# SIGNAL\_OK stability

In support of comments against IEEE 802.3ct D1.2

Comment #: 11, 17, 29, 32, 35

Leon Bruckman (Huawei)

Figure 153–2—SC-FEC functional block diagram

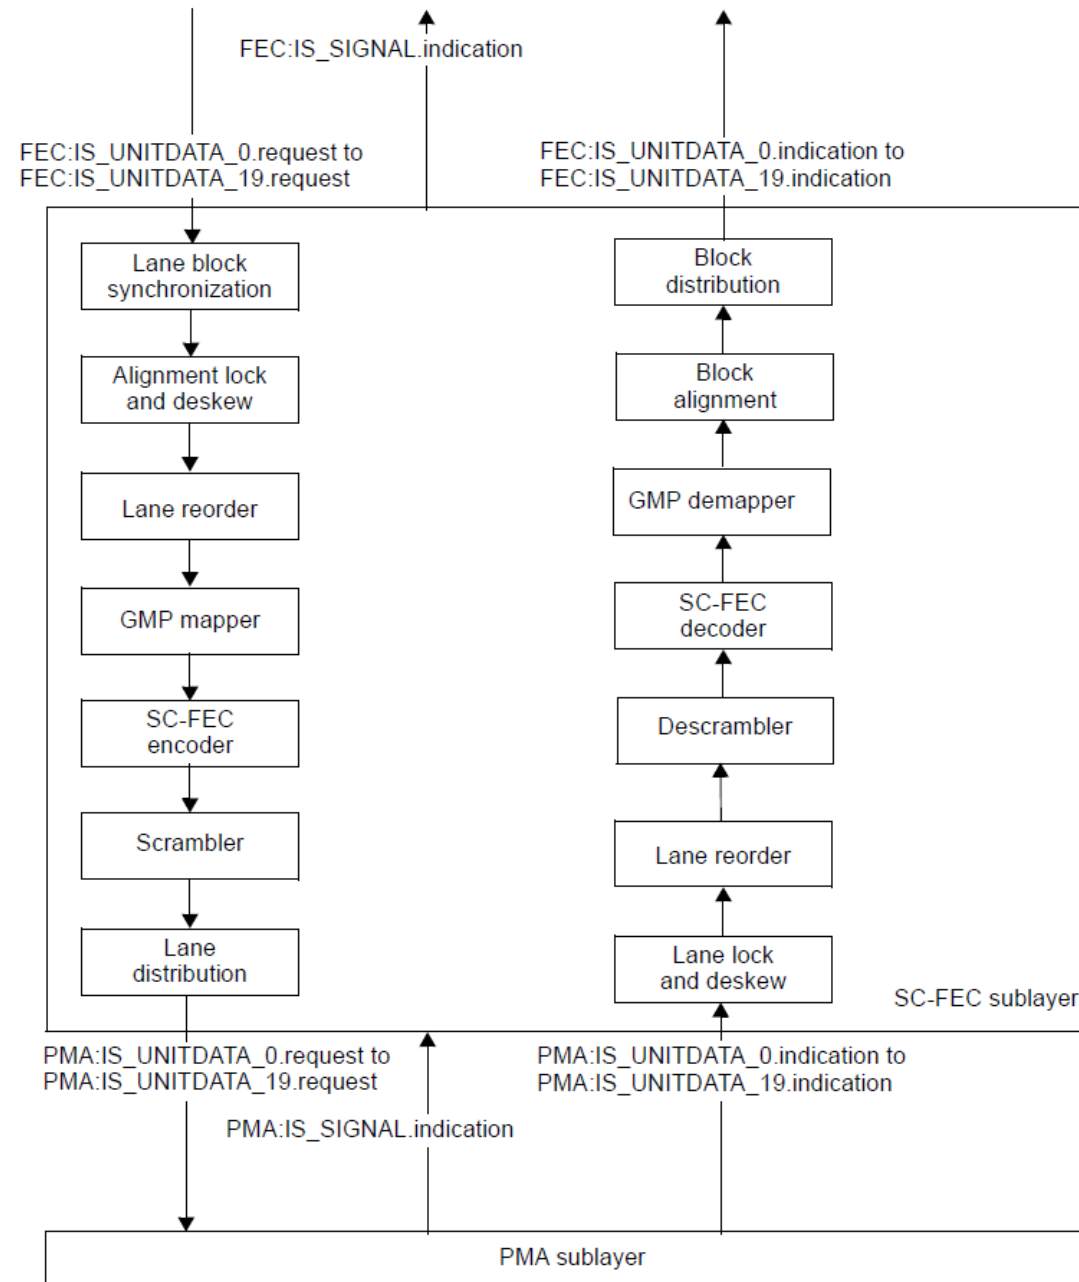
- Instead of using the pre-FEC `fec_align_status` variable that is “noisy” use the `rx_block_lock` signal from Figure 82–12 Block lock state diagram.
  - `Rx_block_lock` is after-FEC
  - In any case it seems we need to use this indication since if `rx_block_lock` is FALSE we should set `SIGNAL_OK` to FAIL.
- Change
  - The `SIGNAL_OK` parameter of the `FEC:IS_SIGNAL.indication` primitive can take one of two values: OK or FAIL. The value is set to OK when ~~the FEC receive function has identified codeword boundaries as indicated by `fec_align_status`~~ `rx_block_lock` equal to true. That value is set to FAIL when ~~the FEC receive function is unable to reliably establish codeword boundaries as indicated by `fec_align_status`~~ `rx_block_lock` is equal to false. When `SIGNAL_OK` is FAIL, the `rx_bit` parameters of the `FEC:IS_UNITDATA_i.indication` primitives are undefined.
